Subject: AP1000 Response to Request for Additional Information (TR09)

Westinghouse is submitting a revised response to the NRC requests for additional information (RAI) on AP1000 Standard Combined License Technical Report (TR) 09, APP-GW-GLR-005, Containment Vessel Design Adjacent to Large Penetrations. This RAI response is submitted in support of the AP1000 Design Certification Amendment Application (Docket No. 52-006). The information included in the response is generic and is expected to apply to all COL applications referencing the AP1000 Design Certification and the AP1000 Design Certification Amendment Application.

AP1000 TECHNICAL REPORT REVIEW

Figure 2-6.1 Typical Nozzle FEA Model

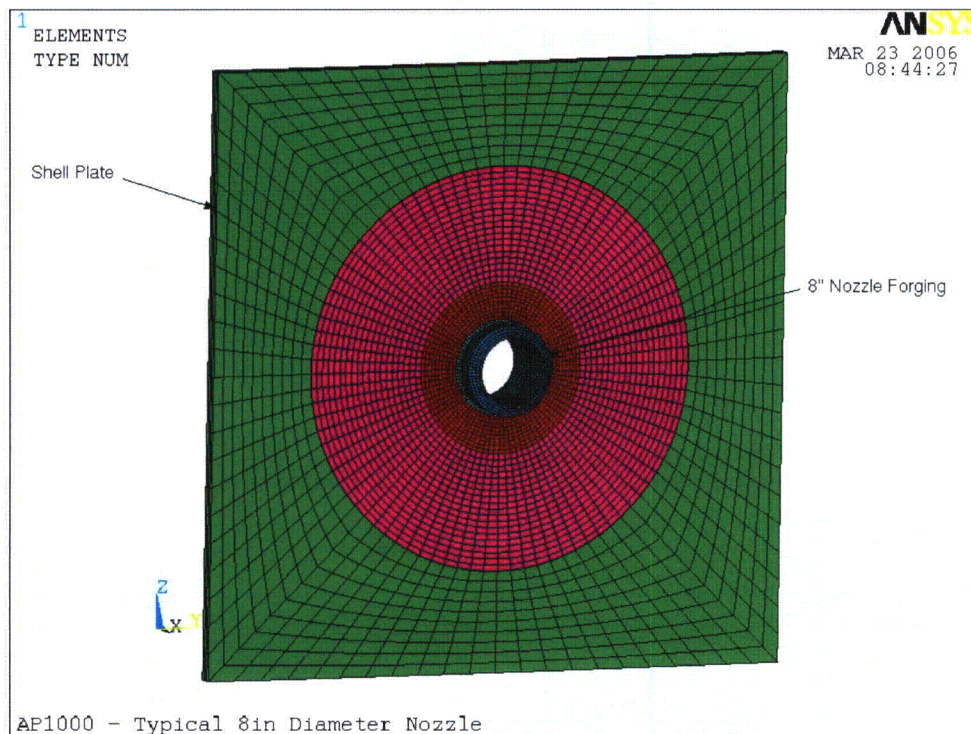
The Main Steam and Feedwater penetrations are not addressed in TR-9. These are important major penetrations, which potentially induce cyclic thermal and mechanical loading in the steel containment vessel, around the periphery of the penetrations. The staff requests the applicant to include the design and analysis details for the Main Steam and Feedwater penetrations in TR-9.

The penetration reinforcement and local region of the vessel shell have been analyzed for unit external loads, for selected typical nozzle configurations, by finite element analyses. A typical finite element

model is shown in Figure 2-6.1. Corresponding stresses were determined at selected points of interest, such as every 10 degrees around the circumference of the nozzle at the attachment fillet weld toe and at a distance of $.5\sqrt{Rt}$ from the nozzle wall.

Figure 3.8.2-4 (Sheet 2 of 6)
Containment Penetrations Startup Feedwater

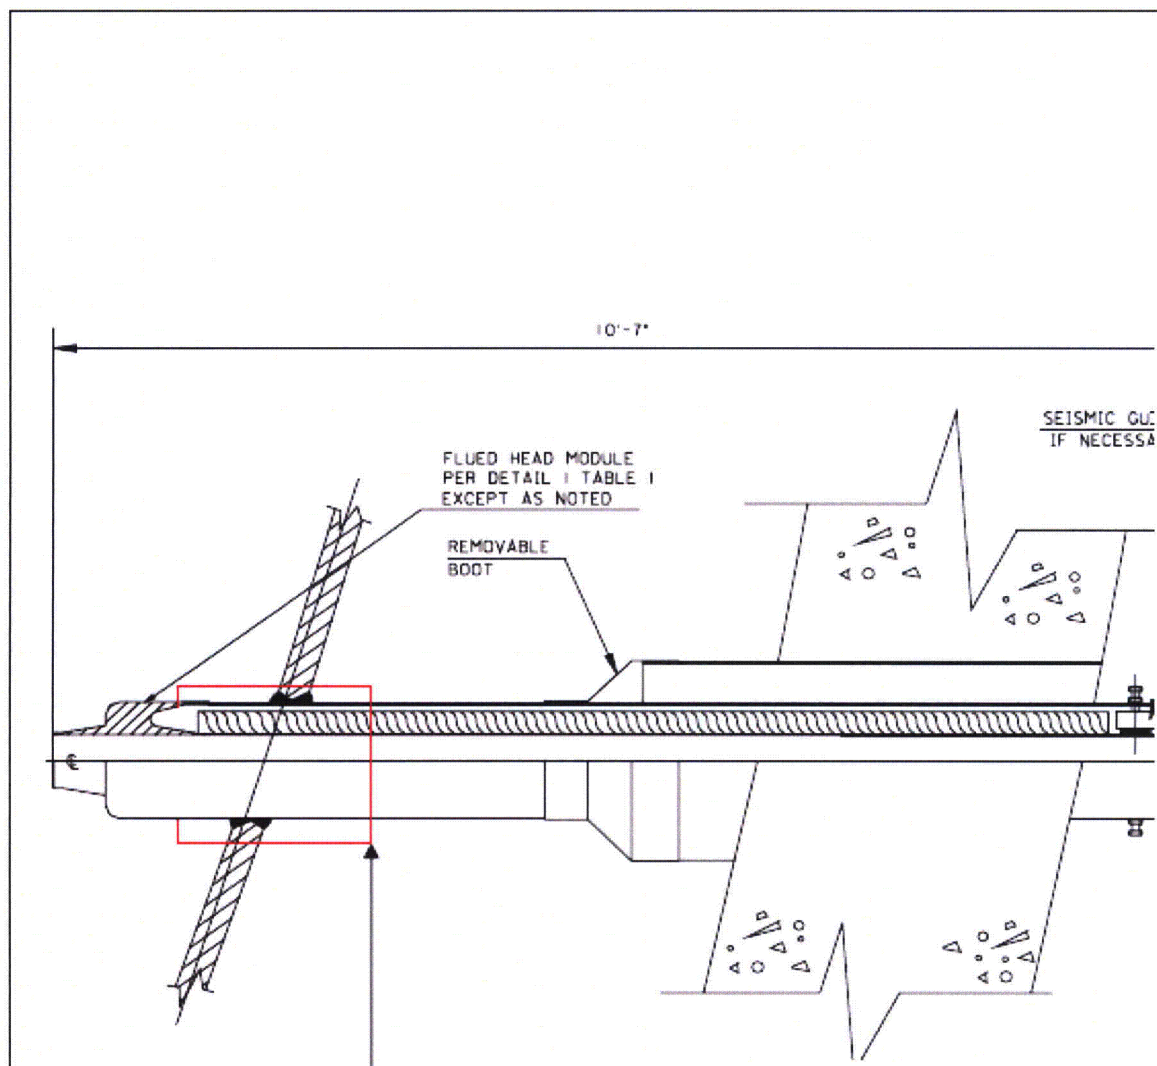
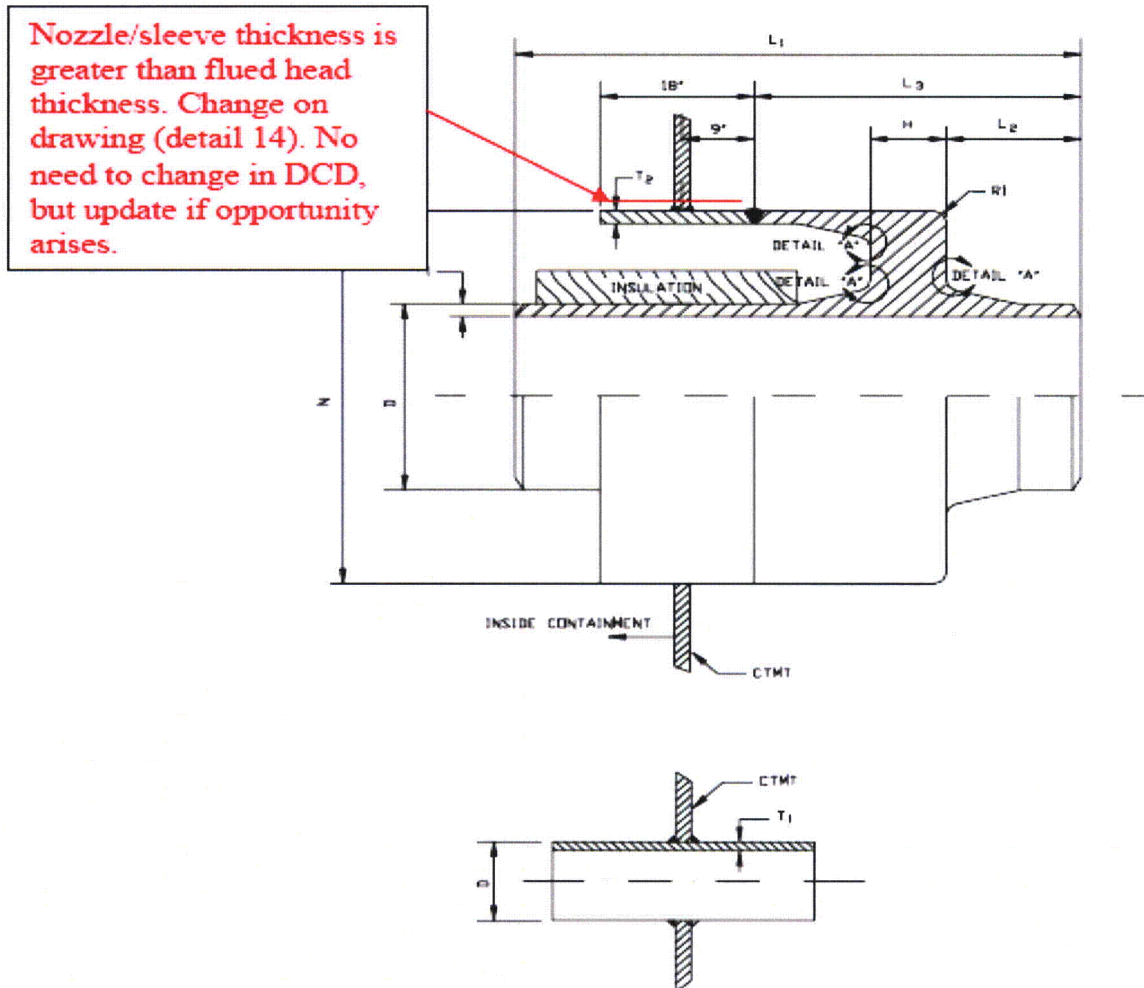
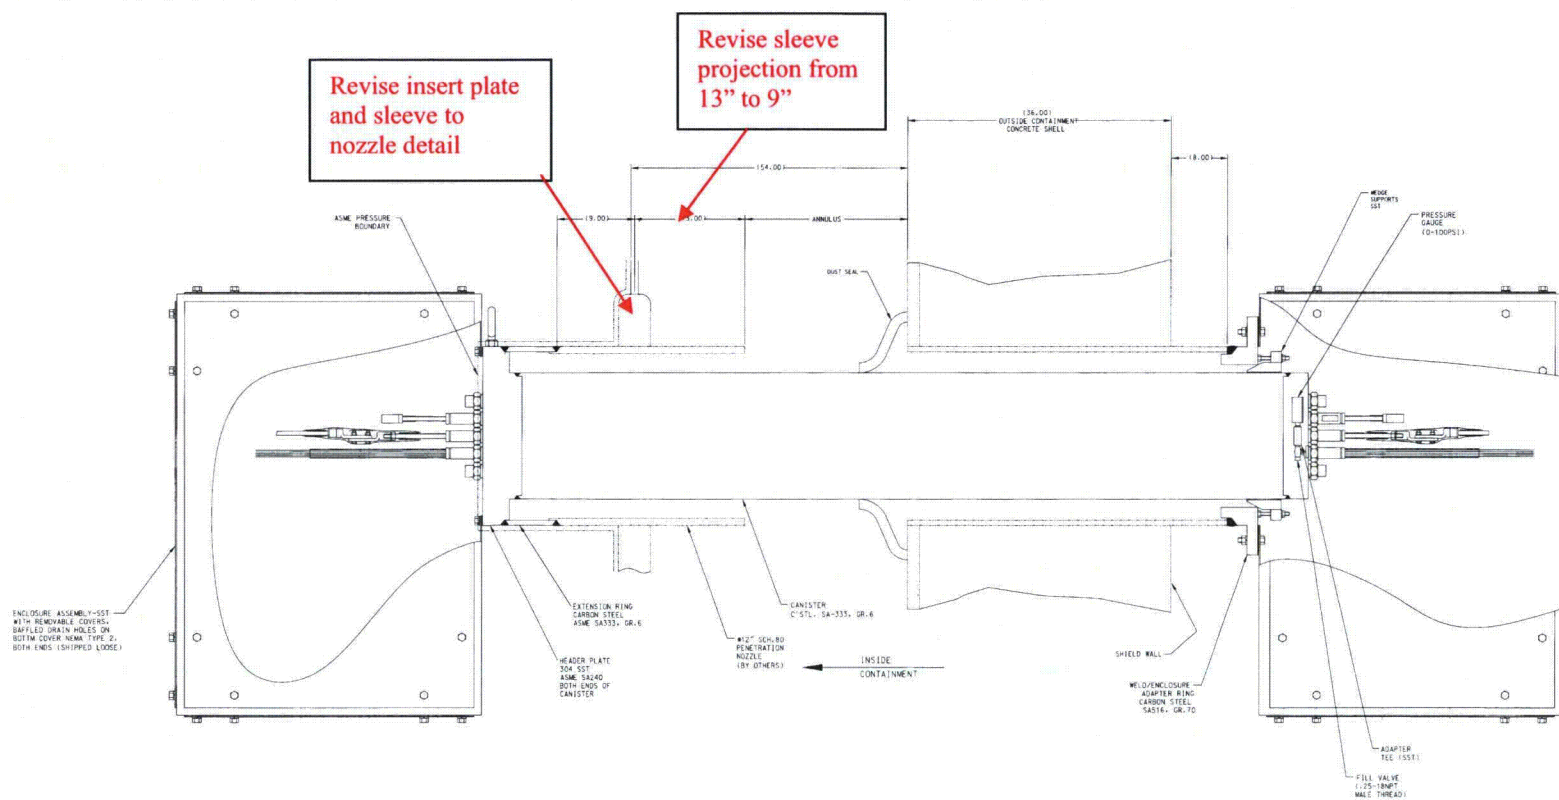
There are no design details for the penetrations in TR-9. The staff requests the applicant to include design information (geometry, material and material properties, dimensions and wall thicknesses) for each penetration in TR-9. Also specify the ASME Code, Class MC jurisdictional boundaries for each penetration.

Revise classification in Table 3.2.3 as shown below from MC to Class 2 for penetrations where the process pipe penetrates directly the containment vessel without the use of a fluid head (see typical detail on lower half of Figure 3.8.2-4, sheet 4 of 6). In this case the sleeve is a boundary of the process fluid and is required by the ASME Code to be Class 2.

Revise sheets 2, 3, 4 and 6 of Figure 3.8.2-4 as shown on the following pages to reflect detail design of the penetration reinforcement.

Figure 2-6(c) – Equipment Hatch (El. 141'-6") Panel – Vertical Section

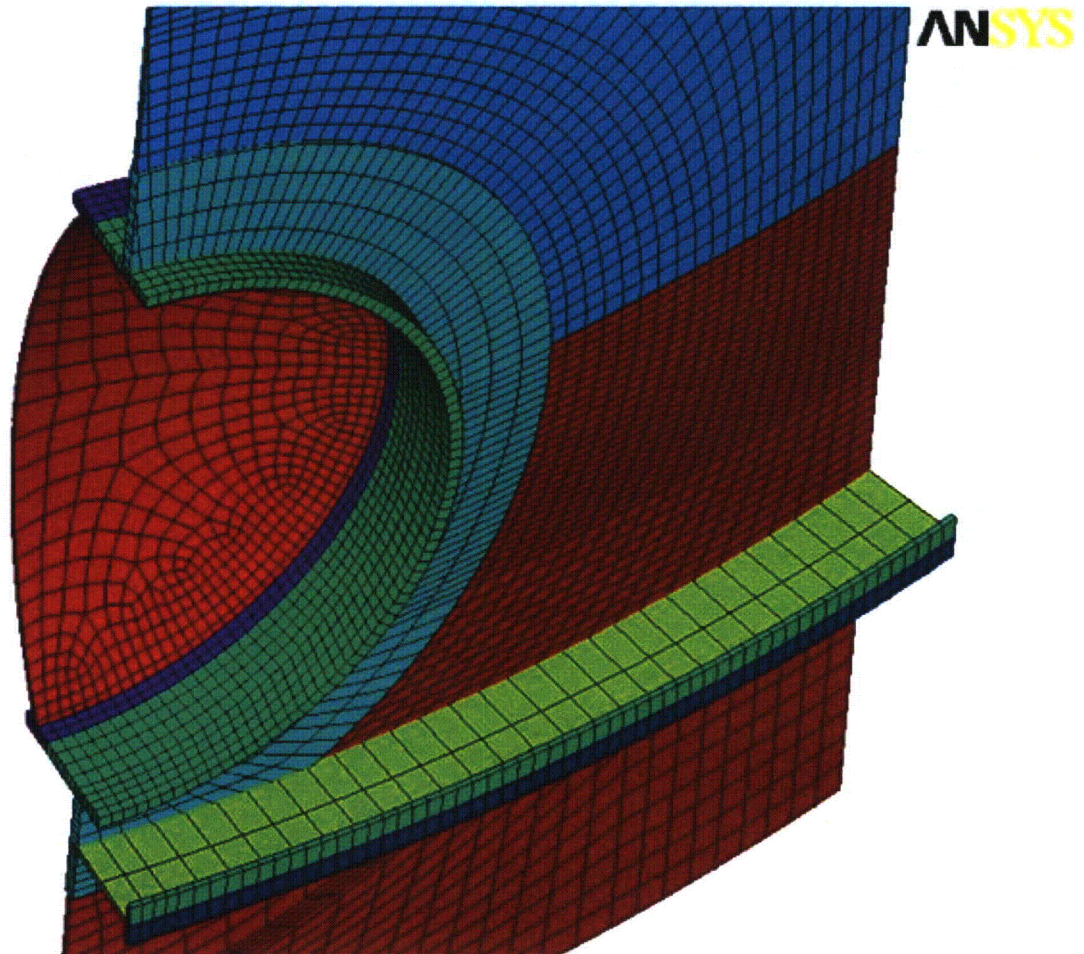
There is insufficient description in TR-9 of the local ANSYS models developed for the penetrations. For each penetration, the staff requests the applicant to address the following in TR-9:

- How is local thickening of the containment vessel modeled?
- How is the ANSYS output used to conduct the ASME Code stress checks?
- What ASME categories of stresses are directly obtainable from the ANSYS results: primary, primary + secondary, primary + secondary + peak?

Subsequent to the initial response to this RAI the NRC requested a revised Figure 2-6(b) in APP-GW-GLR-005 to show the thickened portion of the containment. An additional figure to supplement Figure 2-6(b) is shown below and will be added to the technical report.

Static analyses were performed on a finite element model having greater detail around the penetrations than that described in section 2.1 and used for the time history dynamic analyses in section 2.2. The mesh in the panels around the personnel locks and equipment hatches was refined using elements with a size less than $0.25 \sqrt{Rt}$. Three sub-models were generated, one for the upper personnel lock, one for the upper equipment hatch, and one combined sub-model for the lower personnel lock and equipment hatch. The coarsely meshed panels around the openings in the dynamic model were replaced by the refined mesh panels. The refined model used in static analyses to evaluate the large penetrations is shown in Figure 2-6(a). The refined submodel for the upper equipment hatch is shown in Figures 2-6(b) and 2-6(c).

Add Figure 2-6(c) as follows:

Figure 6.2.1.1-11 AP1000 External Pressure Analysis Containment Pressure vs. Time

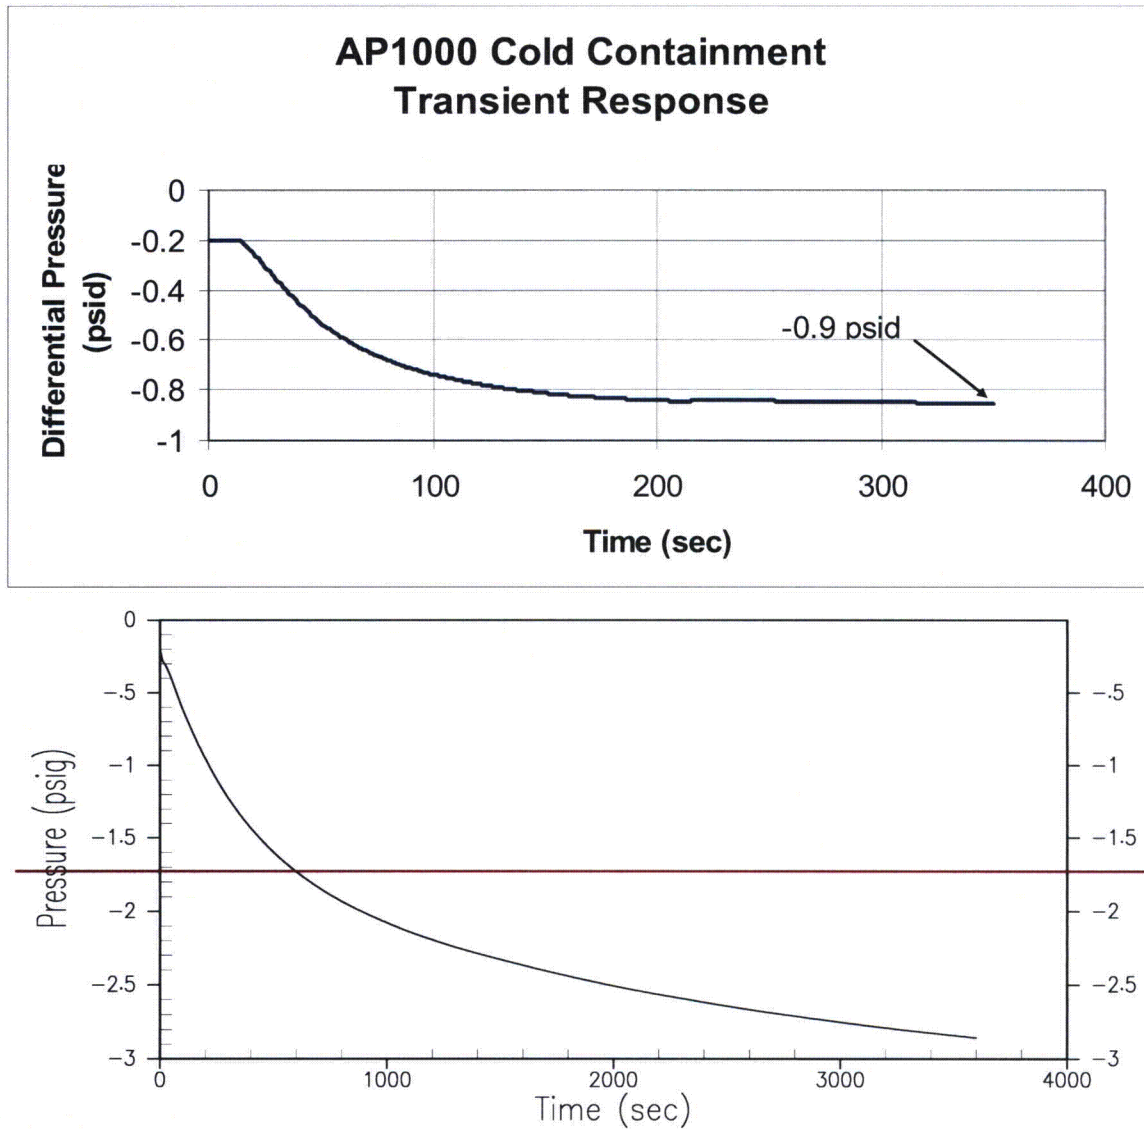
In TR-9, starting on p. 4, Westinghouse presents a justification for reducing the design external pressure from 2.9 psid to 0.9 psid, and states that "the extreme conservatism in the above analyses was reduced and an estimate of the external pressure was provided in the response to DSER Open Item 3.8.2.1-1." The staff reviewed the AP1000 SER and could not establish that this reduction has been specifically reviewed and accepted by the staff. The staff also reviewed AP1000 DCD, Rev. 15, and found that the design external pressure is specified to be 2.9 psid on page 3.8-1. Since there is no evidence that the reduction in design external pressure has been reviewed and accepted by the appropriate staff reviewers, and a determination of acceptability cannot be made by staff structural reviewers, Westinghouse must use the design external pressure of record (i.e., 2.9 psid) in demonstrating the adequacy of the containment penetration designs. Therefore, the staff requests the applicant to

- Demonstrate the design adequacy of the containment penetrations for a design external pressure of 2.9 psid.
- Confirm the design adequacy of the steel containment vessel (other than penetrations) for a design external pressure of 2.9 psid.

For consistency with Figure 6.2.1.1-11, the words 'at one hour' were deleted from the text in section 6.2.1.1.4 of the DCD, Revision 16. This change and all other DCD changes shown below were incorporated in Revision 5 of APP-GW-GLR-134 (Technical Report 134).

Certain design basis events and credible inadvertent systems actuation have the potential to result in containment external pressure loads. Evaluations of these events show that an inadvertent actuation of active containment cooling a loss of all ac power sources during extreme cold ambient conditions has the potential for creating the worst-case external pressure load on the containment vessel. This event leads to a reduction in the internal containment heat loads from the reactor coolant system and other active components, thus resulting in a temperature reduction within the containment and an accompanying pressure reduction. Evaluations are performed to determine the maximum external pressure to which the containment may be subjected during a postulated actuation of the active containment cooling loss of all ac power sources.

Evaluations are performed using WGOTHIC with conservatively low estimates of the containment heat loads and conservatively high heat removal through the containment vessel consistent with the limiting assumptions stated above. Results of these evaluations demonstrate that at one hour after the event the net external pressure is approximately -0.9 psid which is within the capability of the containment vessel. The pressure changes very slowly after the initial decrease and there is within the 2.9 psid design external pressure. This is sufficient time for operator action to prevent the containment pressure from dropping below the -0.9 psid external pressure, based on the PAM's containment pressure indications (four containment pressure instruments) and the ability to mitigate the pressure reduction by opening either set of containment ventilation purge isolation valves, which are powered by the 1E batteries.
